Exhibit L

SUBJECT: DPU CONDITIONS OF APPROVAL FOR P23-00186 MEDICAL OFFICE FACILITY – APNs 427-261-25 AND 427-261-26

SUBJECT: **APPLICATION NO. P23-00186**
3147 E. GETTYSBURG AVE.

SUBJECT: Conditions of Approval for **P23-00186**

PROPOSED SITE PLAN

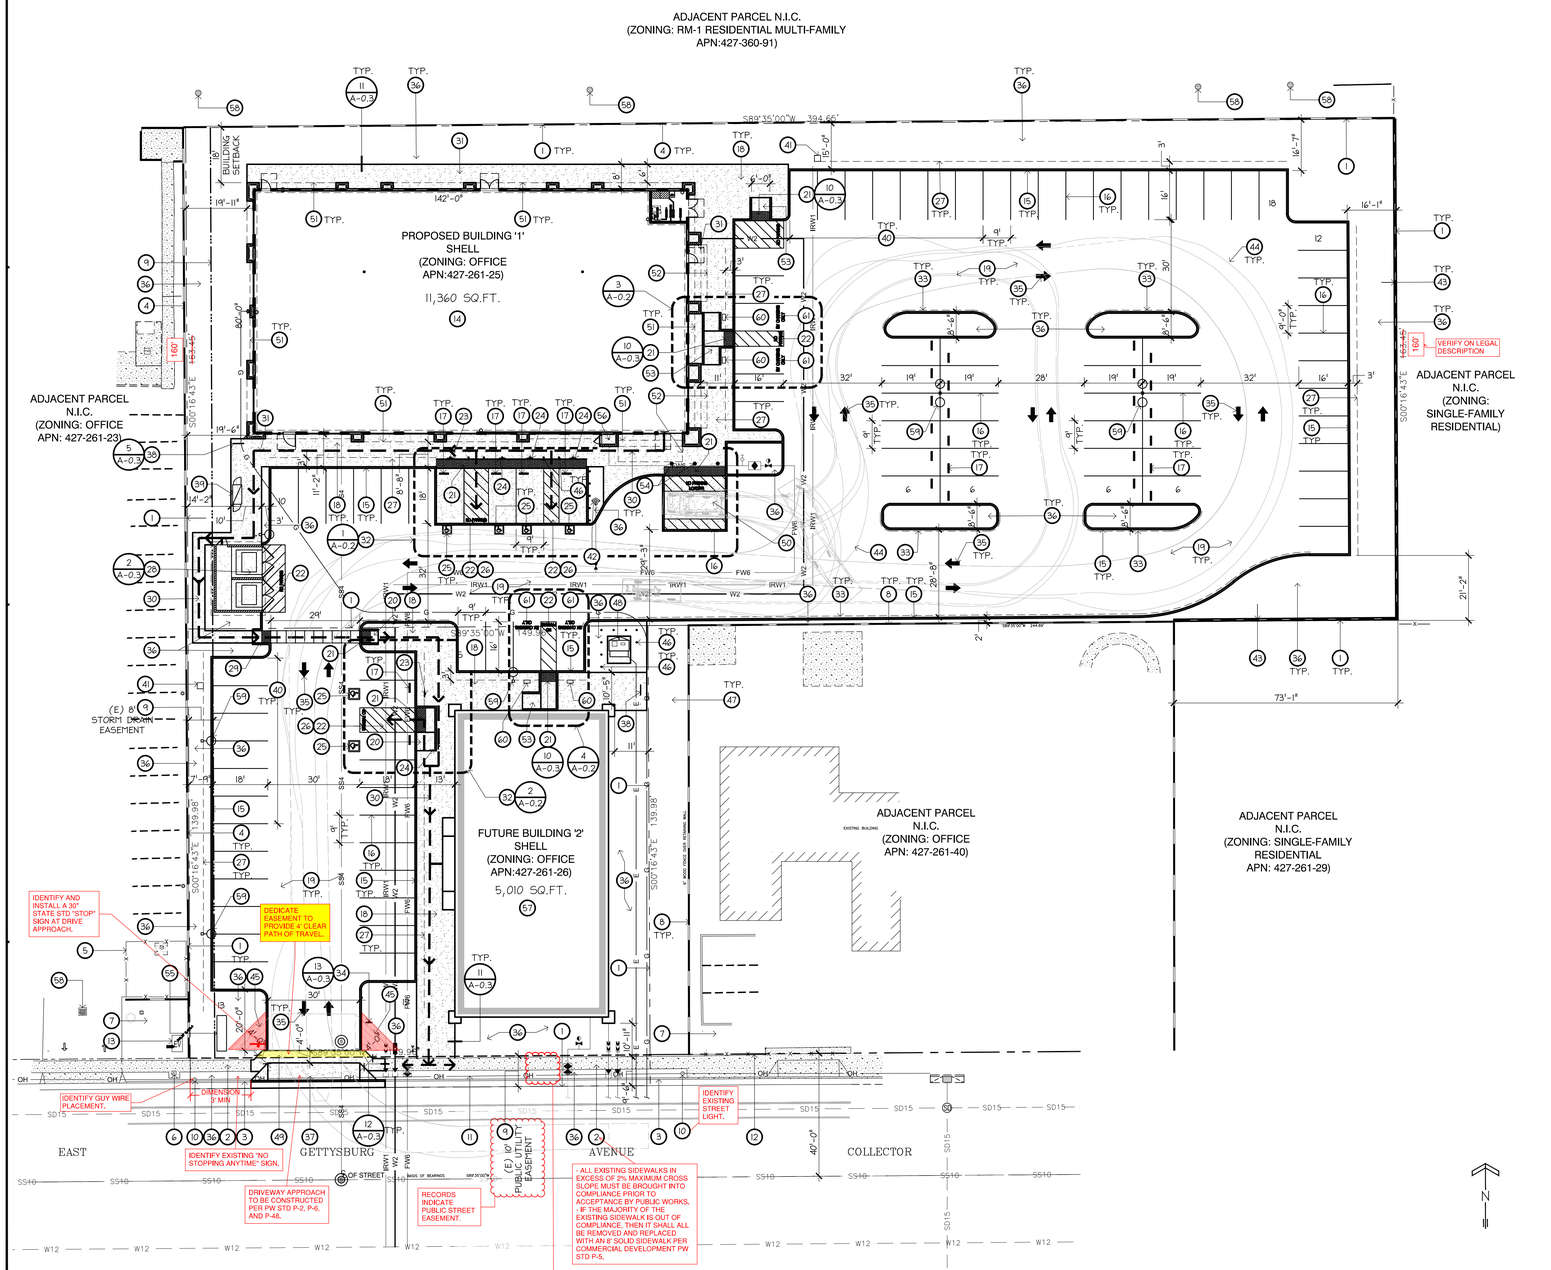
ATTENTION:
Provide corrections as noted on Exhibit "A-2".
Prior to resubmitting the corrected exhibit, provide the following information and conditions of approval on the site plan:

IDENTIFY SIDEWALK DRAINS PER PW STD P-23.

IDENTIFY DIMENSIONS. OUR RECORDS INDICATE 8' PATTERN: FACE OF CURB TO WALK 3.5'. SIDEWALK 4'. BACK OF WALK TO RIGHT-OF-WAY .5'. VERIFY

PROVIDE LEGAL DESCRIPTION

49. LOCATION OF NEW PUBLIC IN-FILL SIDEWALK PER ~~CITY STANDARDS~~. — PW STD P-5.
50. LOCATION OF NEW REINFORCED CONCRETE CAMEL HUMP FOR A ZERO CURB LOADING AREA - REFER TO ENLARGED SITE DETAIL FOR ADDITIONAL INFORMATION.

19. LOCATION OF NEW AC PAVING. — PER PW STD P-21, P-22, P-23
20. LOCATION OF NEW CURB CUT RAMP FOR ACCESSIBLE PATH.
21. LOCATION OF NEW TRUNCATED DOMES OVER NEW CONCRETE - 6" FROM FACE OF FLOW LINE BY 36" DEEP BY FULL WIDTH OF ZERO CURB - YELLOW AND APPROXIMATELY F533536 OF FEDERAL STANDARD 595C OR PROVIDE 70% MIN VISUAL CONTRAST WITH ADJACENT WALKING SURFACES.

36. LOCATION OF NEW LANDSCAPING AND IRRIGATION - SEE LANDSCAPE PLANS.
37. CONSTRUCTION OF NEW DRIVE APPROACH - PER ~~CITY STANDARDS~~. — PW STD P-2, P-6, AND P-48
